**Planning Department  
Transportation Development Services**

**Re: Office Warehouse, 3440 2<sup>nd</sup> Street NW**  
**Traffic Circulation Layout**  
Engineer's/Architect's Stamp dated 10-20-14 (G14-D087)

Based upon the information provided in your submittal received 10-22-14, the above referenced plan cannot be approved for Building Permit until the following comments are addressed:

AREA SITE PLAN

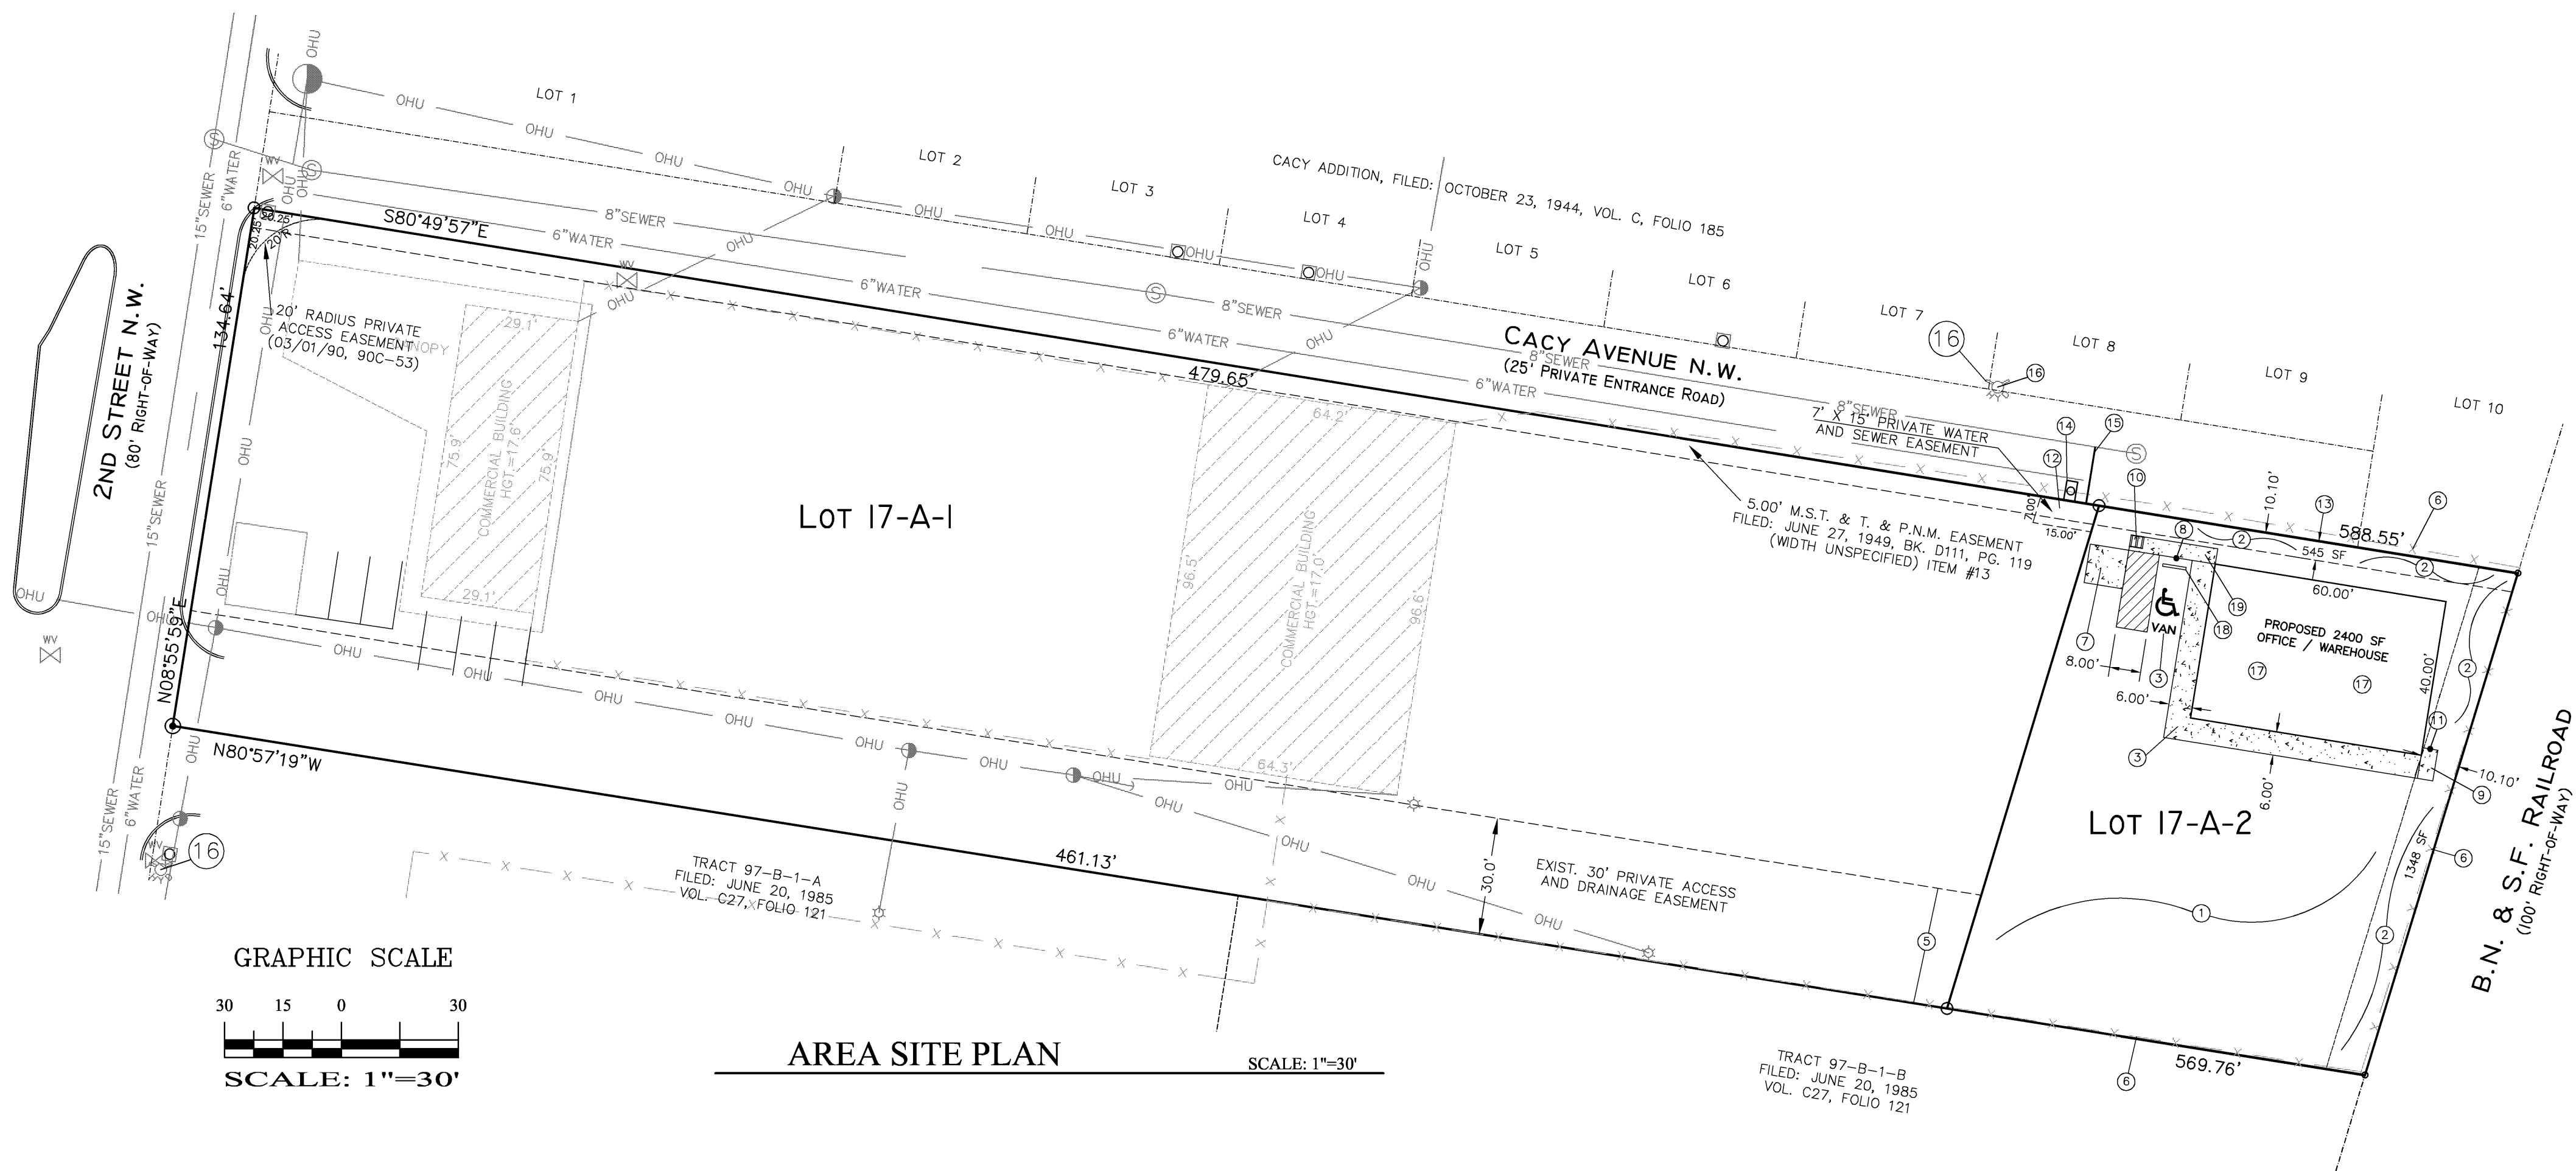
1. Label each existing building on Lot 17-A-1 as "Existing Building to Remain", and label the existing pavement width and/or gravel roadway width on adjacent roadways. Show existing access to Lot 17-A-1.

PROPERTY SITE PLAN

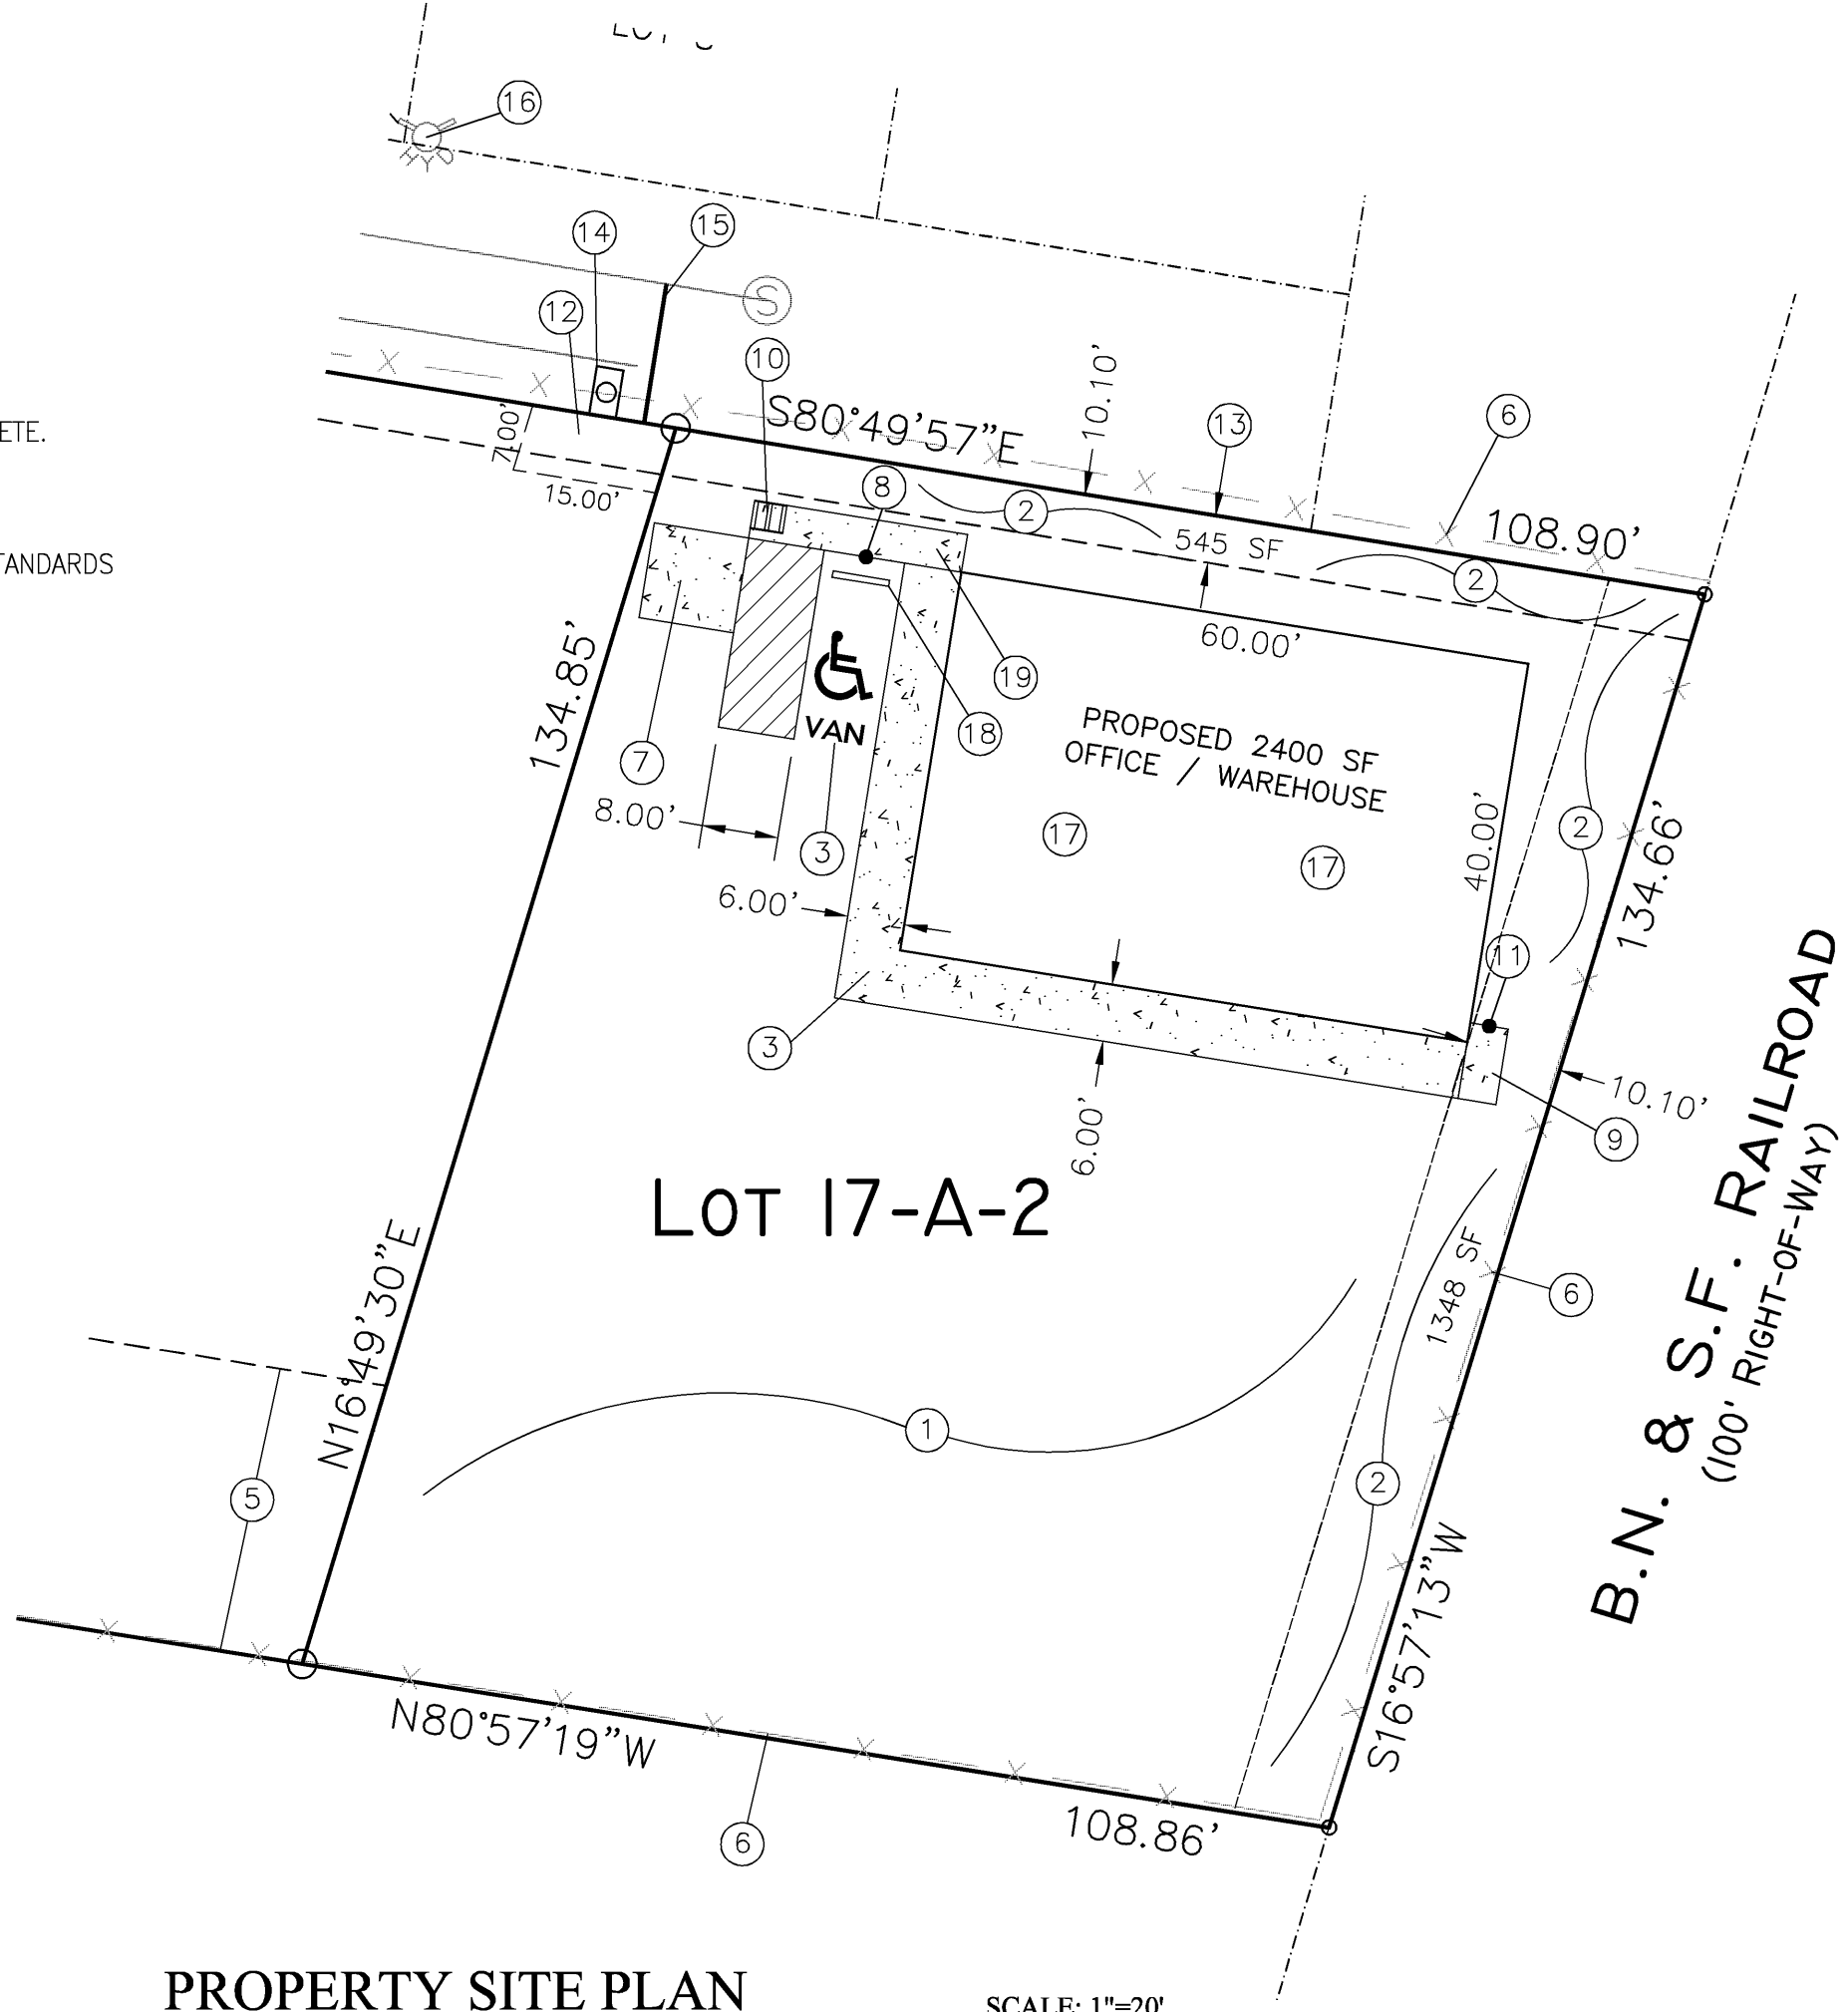
2. Label the DRB case number for the Existing 30-foot Private Access and Drainage Easement.
3. Please identify all the proposed doors for the proposed office and warehouse including handicapped access and the proposed garage doors for the proposed parking inside the warehouse. Show all door widths.

4. Please list the width and length for all parking spaces. The handicap accessible spaces must be a minimum of 8.5 feet in width and 18 feet long.
5. The ADA van accessible sign must have the required language per 66-7-352.4C NMSA 1978 **"Violators Are Subject to a Fine and/or Towing."**

7. For Lot 17-A-2, extend the proposed 6-foot sidewalk all of the way to the property line along the south side of Casey Avenue.
8. Handicapped access is required to be paved. Both the handicapped parking space and the van accessible space must be paved. The remaining driving area may be recycled asphalt or gravel as called out by Keyed Note 1 on the site plan. Maintain the new 6-foot sidewalk as concrete or asphalt as called out

- on the site plan as per Keyed Note 3 as long as a different surface is provided for the pedestrian walkway than the driving area. For the asphalt surface, show the thickness of asphalt proposed.
9. The bike rack called out by Keyed Note 10 on the site plan is in the way of the handicapped access from the van accessible aisle and needs to be moved to a location where it does not interfere with wheelchair access.
  10. "Chain link fence" is misspelled on Keyed Note 6.
